UNITED STATES PATENT AND TRADEMARK OFFICE

Office Action Summary

This is a third office action for serial number 10/067161, entitled Suspended Ceiling Panel Edge and Rib Technology, filed on February 4, 2002.

FIG. 1

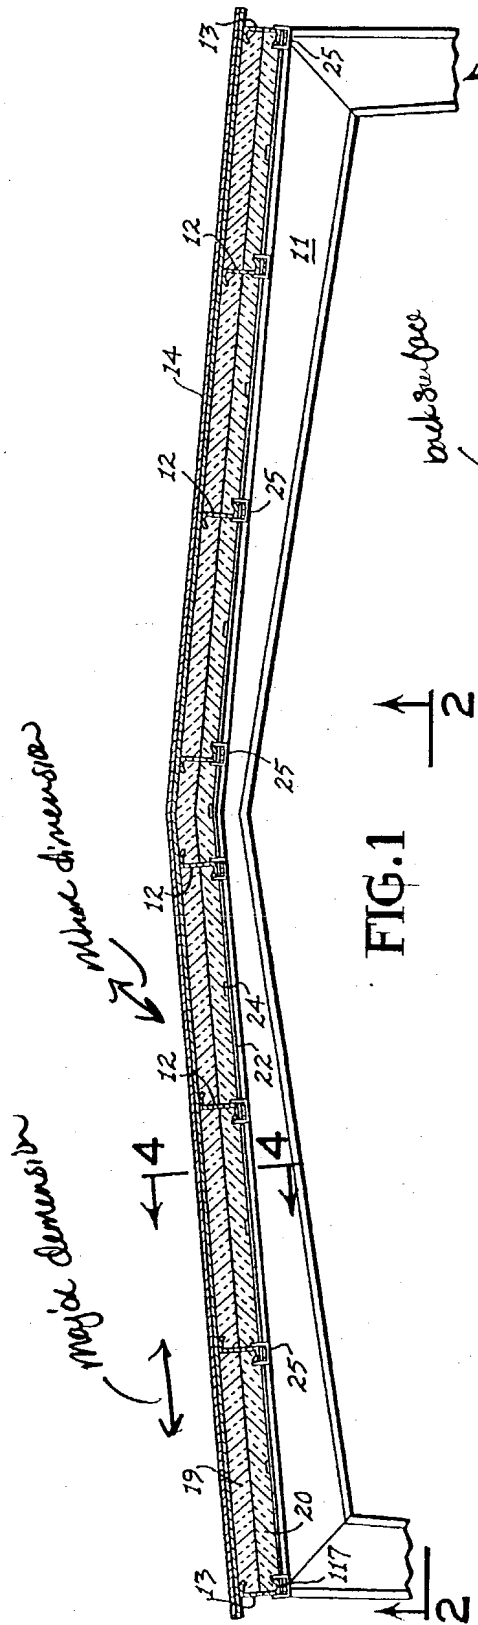
In regards to claims 1, 2 and 4, Sparkes discloses the claimed invention a surface panel (19) with a major and minor dimension and a thickness dimension (see attached figures 1 and 3), a side edge of the panel (at 12) corresponding to the thickness dimension, a face surface (at 21) of the panel facing toward a room and substantially coplanar with a plane defined by the major and minor dimensions (figure 1), a back surface of the panel being opposite of the face surface (see attached figure 3), the panel edge is multifaceted and includes a first surface (at 12) intersecting the back surface (see attached figure 3), a second surface (see attached figure 3) intersecting the first surface and substantially parallel to the face surface, a third surface (see attached figure 3) intersecting the second surface and substantially orthogonal to the face surface and a fourth surface (see attached figure 3) intersecting and being beveled relative to the third surface (beveled relative to third surface – by definition: the angle that one surface or line makes with another when they are not at right angles); the **fourth surface (see attached figure 3) intersects the face surface surface**; and, the first surface (at 12) is substantially orthogonal to the back surface (see attached figure 3).

FIG. 3

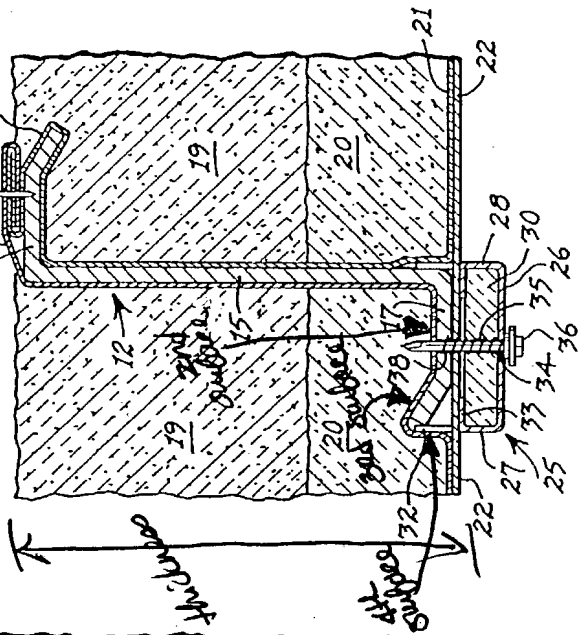
In regard to claims 38-41, Sparkes further discloses the fourth surface (see attached figure 3) is a continuous surface (by continuing into the face surface and the third surface); the third surface is relatively more outboard than the first surface (the third surface is more outboard to the face surface than the first surface); the first, second, third and fourth surfaces together present a generally convex conformation

(convex in correlation to the panel, 19 and 20, itself); and, the fourth surface is substantially planar (see attached figure 3).
